POWER PLANT - NACELLE - POWERPLANT - CORE SERVICES HARNESS - REROUTE OF - CATEGORY
CODE 8 - MOD.NAC-71-0138

V2500-NAC-71-0138

LOCATION OF CLIPPING POINT CHANGES
Fig.1

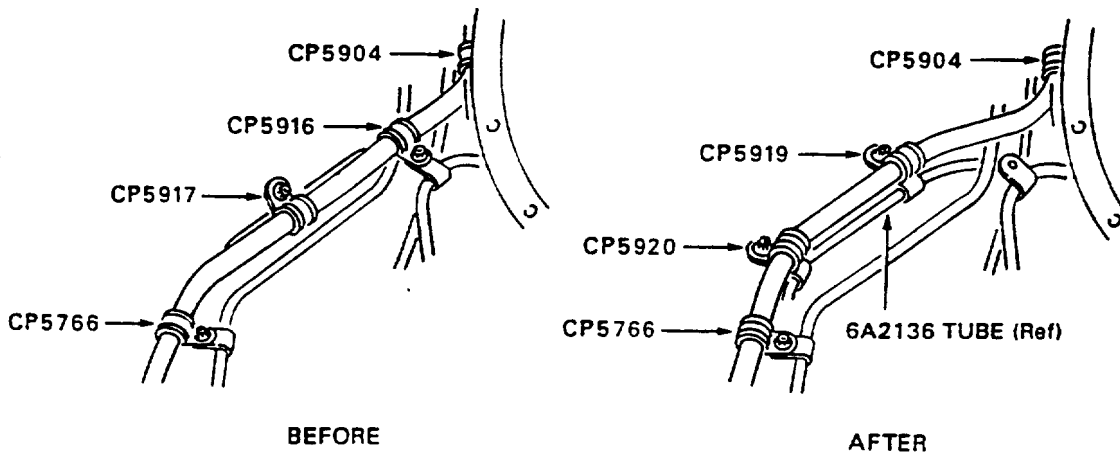
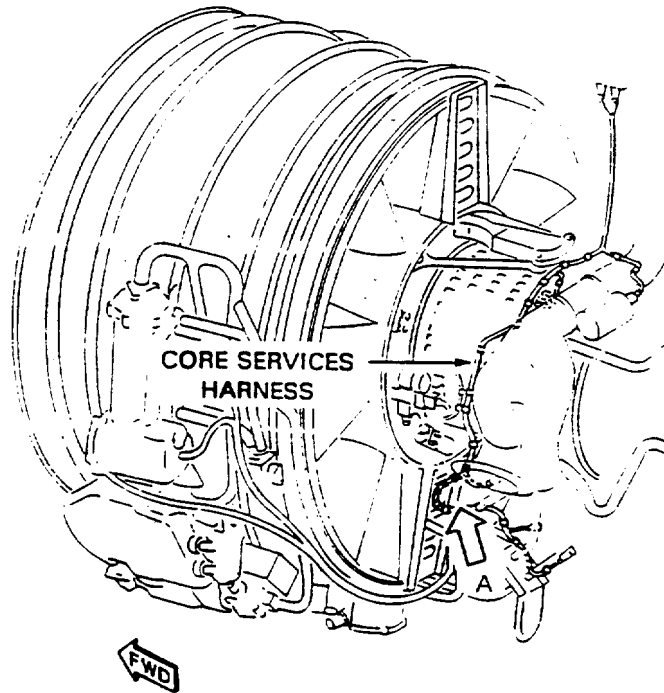
- (a) Clipping points CP5916 and CP5917 on the core services harness are deleted. Two new clipping points replace them: CP5919 and CP5920. The new clipping points are attached to a pneumatic tube local to the old clipping points.

- (1) Find clipping points CP5916 and CP5917 at the bottom of the engine core. See Figure 1.
- (2) Remove the AS21407 bolt, TA025074-03 clamp, AS20624 nut, and SP154D washer from clipping point CP5916. Retain hardware for reinstallation. See Figure 2.

- (3) Remove the AS21407 bolt, TA025074-03 clamp, AS20624 nut, and SP154D washer from clipping point CP5917. Retain hardware for reinstallation.
- (4) Put the 740-5967 core services harness in position for clipping to 6A2136 tube. See Figure 1.
